Independent Technical Review of Navigation Studies

**Contract No. SAA-12966,
Independent Technical Review of Navigation
Channel Improvement Studies**

PEER REVIEW

**Autoridad de Canal de Panama
Canal Capacity Office**

RMC Production Cut/Lake Monthly Production

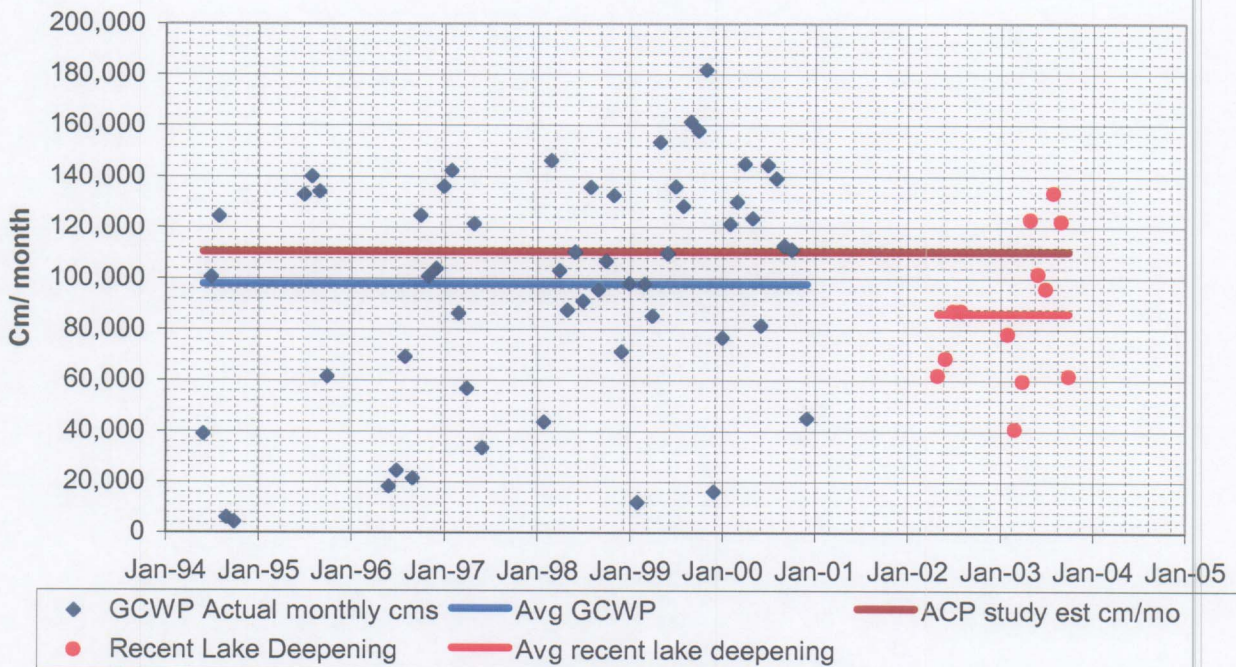
The graph above shows the monthly production achieved by the RMC during the GCWP (blue) as well as the monthly production achieved during the recent lake deepening work (red). It also shows the monthly production expected in the ACP study (brown).

The RMC production records for the on-going cut/lake deepening were not provided but total monthly productions from graphs on display in the dredging division office are used. Those monthly totals are shown in the graph above in red. Over the period of May 02' to Oct 03', the RMC has averaged 86,346 m³s per month, roughly 20% under the estimate used in the Study.

This points out a significant failing of the ACP estimate. The best information to rely on for estimating the cost and time of the project is the on-going project itself. The recent production records of the Thor on the cut/lake deepening project are included in the study and relied on but the RMC and MINDI records are not.

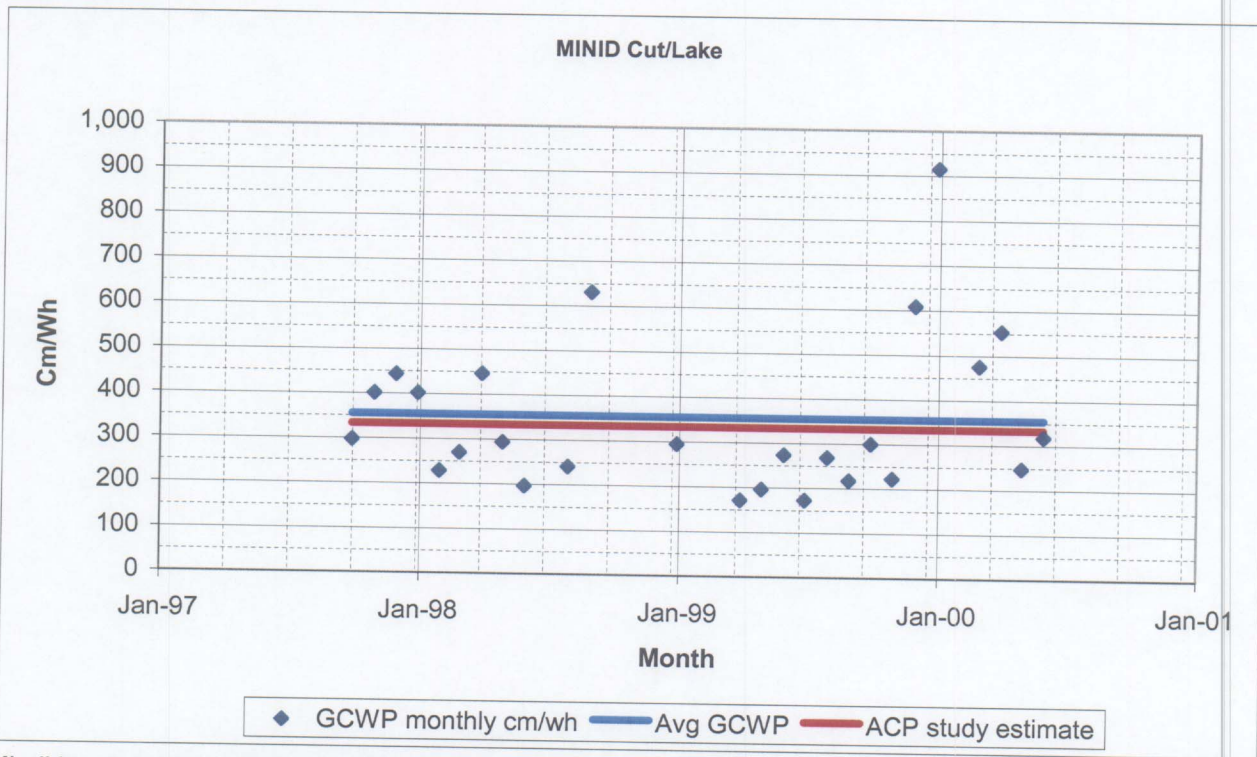
For comparison purposes, GL has used the actual production on the recent work when calculating a "GL Optimized" estimate. Since only monthly totals of the on-going work are available, 27 operating days a month are assumed and 15.7 hours per day (GCWP average) to back into a digging production rate of 196 m³/wh.

Determining whether or not the RMC could do better than the recent experience of +/- 90k m³s/month would require a detailed analysis of the current records. Questions to be answered include:

Mindi hourly production during GCWP (blue) vs. ACP study for cut/lake deepening (brown).

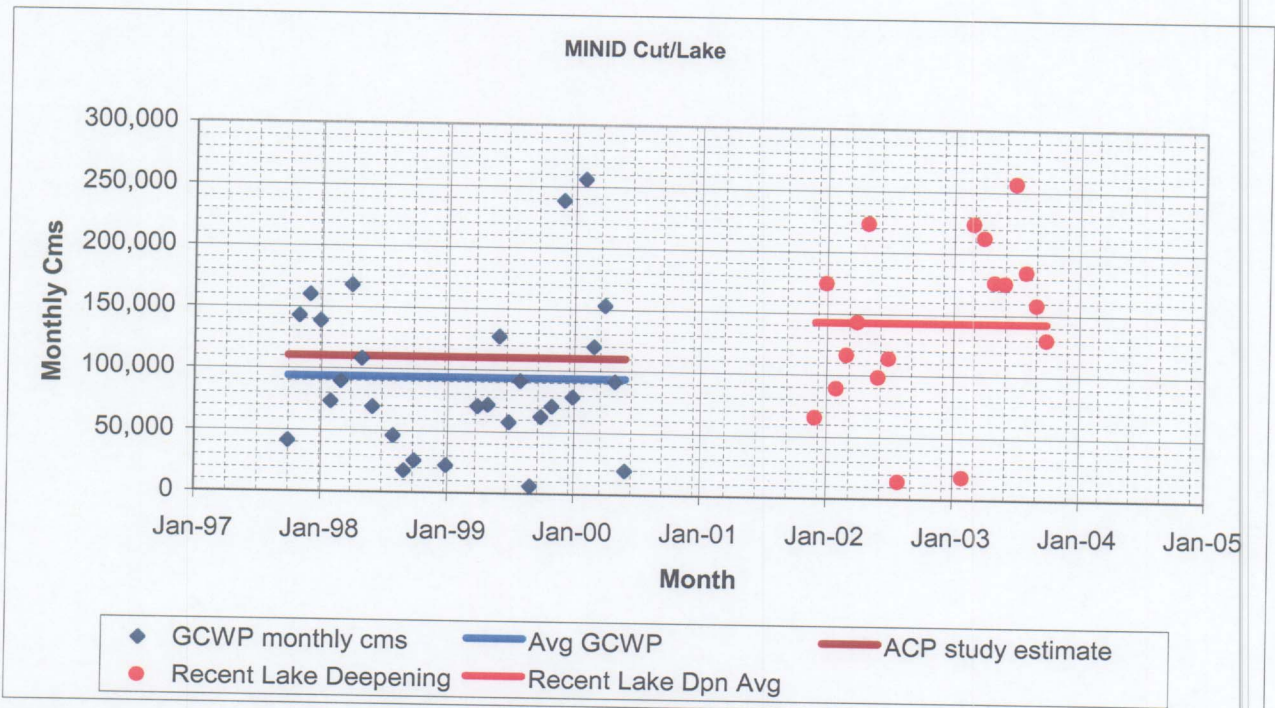
Mindi monthly production in GCWP (brown) and recently lake deepening (red). Also shown is the ACP study of cut/lake deepening estimated monthly production (brown).

In this case, there is better information available in the form of the cut/lake deepening dredging the MINDI has been performing since December of 2001. Between December

01' and October 03', the MINDI has averaged over 140,000 m³s of production, roughly 30% better than the ACP study has estimated. The records for this recent dredging were not included in the study and therefore there is no detail or technically based reason for the improved performance.

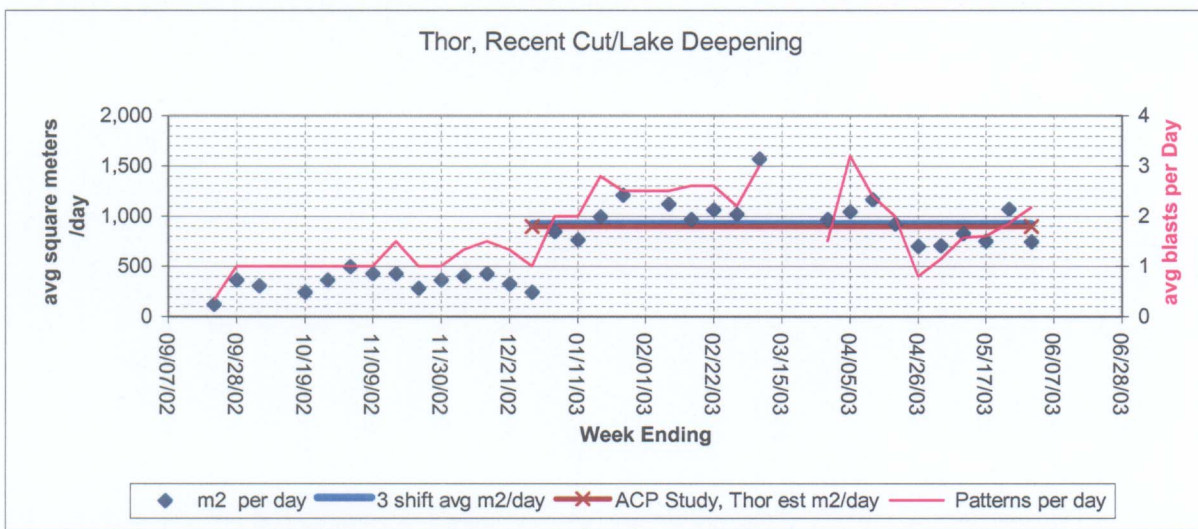
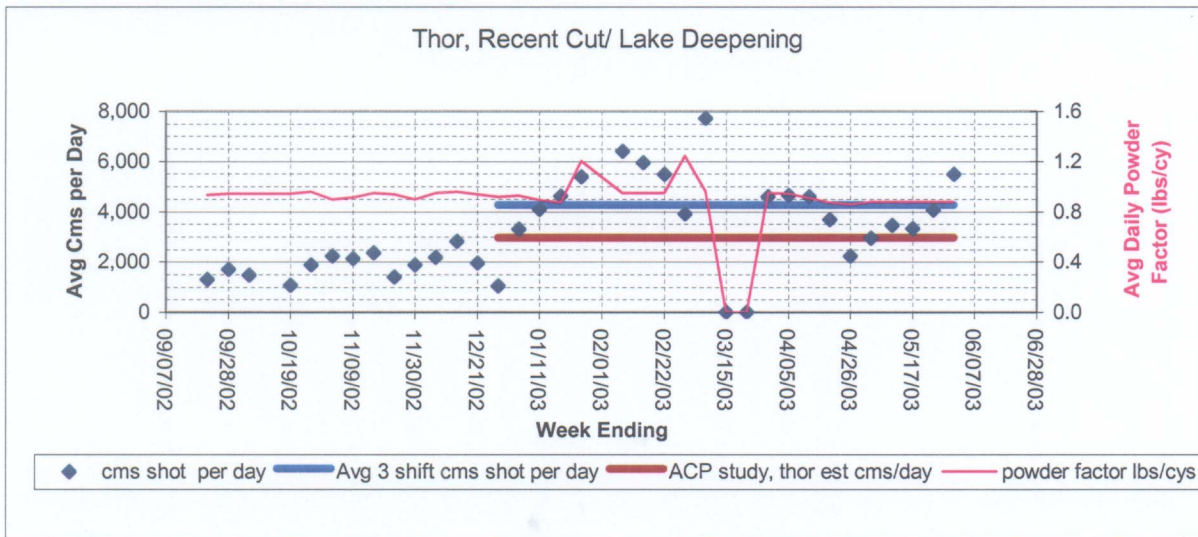
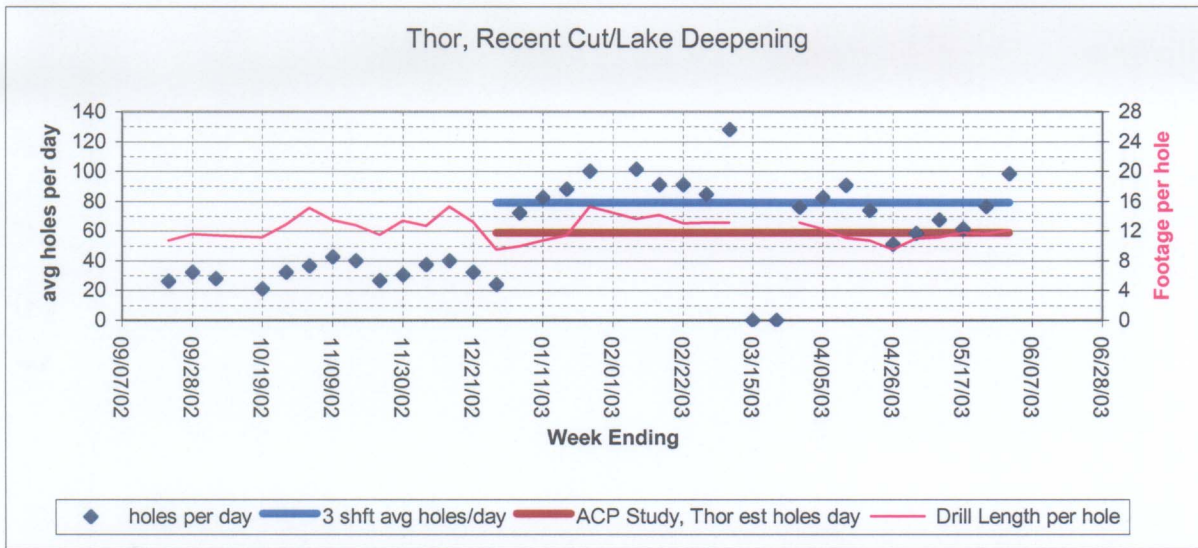
Detailed records for the Thor working on the current cut/lake deepening project were included in the study. Summary of key production parameters as compared to the ACP estimate are shown in the graphs above. Overall, the Thor is covering as much area as expected in the ACP study (+/- 6,300 m²/wk). It is observed that the records to date show an average of a 37 holes over 4,590 ft². The estimate is based on a 32 hole pattern of 5,200 ft², so the Thor is doing more holes and patterns than expected but roughly the same area expected per day.
